ADDENDUM TO MC68341 Integrated Pro

April 19, 1995

Figure 3-12. M68300

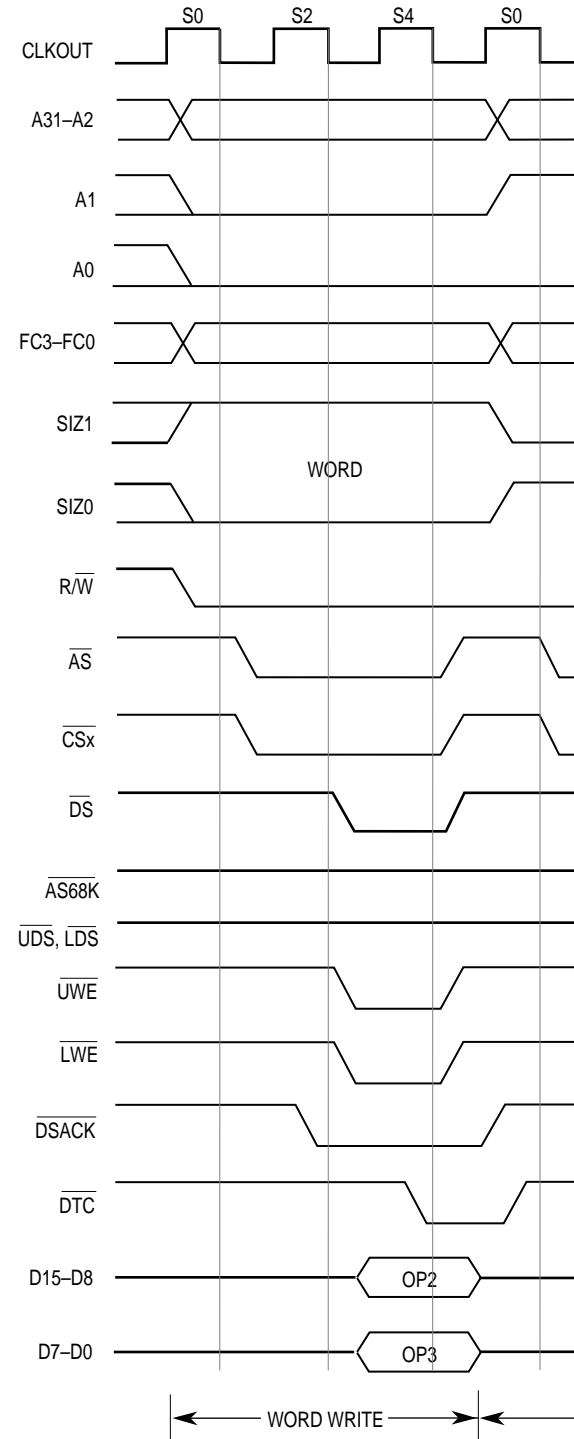
4. Write Cycle Timing Waveforms

On page 3-25, the M68300 write cycle timing diagram \overline{LWE} . On page 3-28, the M68000 write cycle timing diagram \overline{CSx} , $\overline{UDS/LDS}$, and $\overline{UWE/LWE}$. Replace these figures

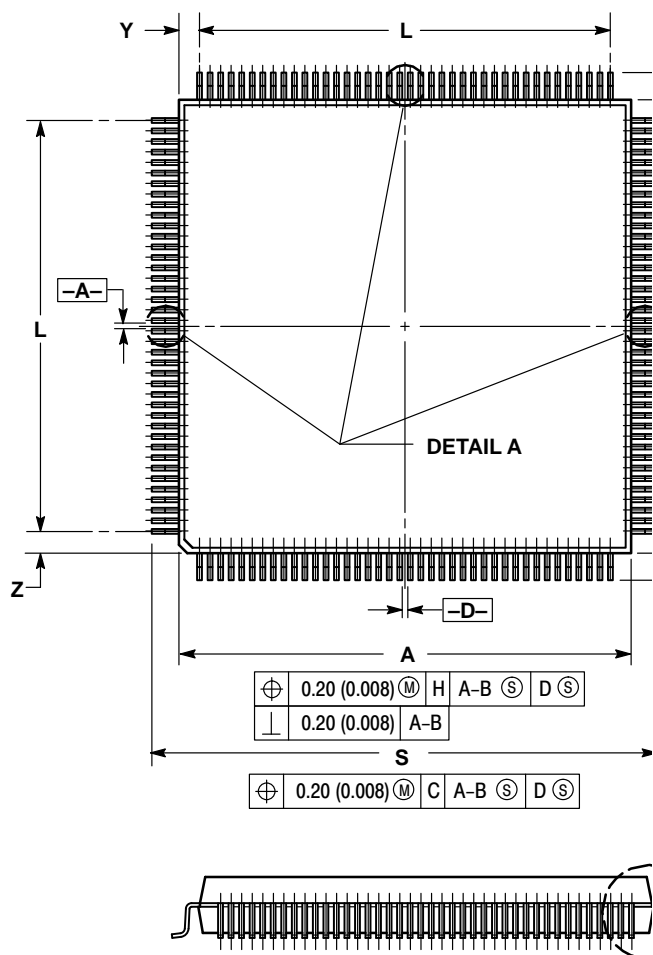
63. Recommended 32KHz Oscillator (

On page 11-2, Figure 11-2, a 10M resistor can be subst

Figure 11-14. Circuit For Interfacing the MC68341 to a Device in Single-Address Mode

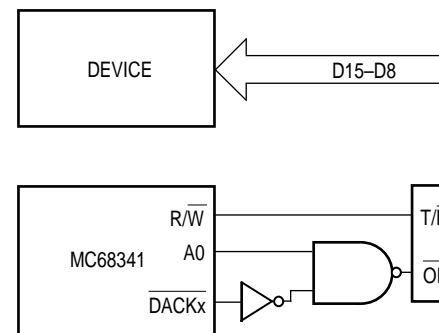
65. Corrections to 8/16-Bit DMA Cont

On page 11-10, the logic driving \overline{OE} on the 74F245 in Figure 11-14 is shown. Although not detailed, the byte enables for the memory block are shown. Attention between the upper and lower bytes of the data bus is shown.
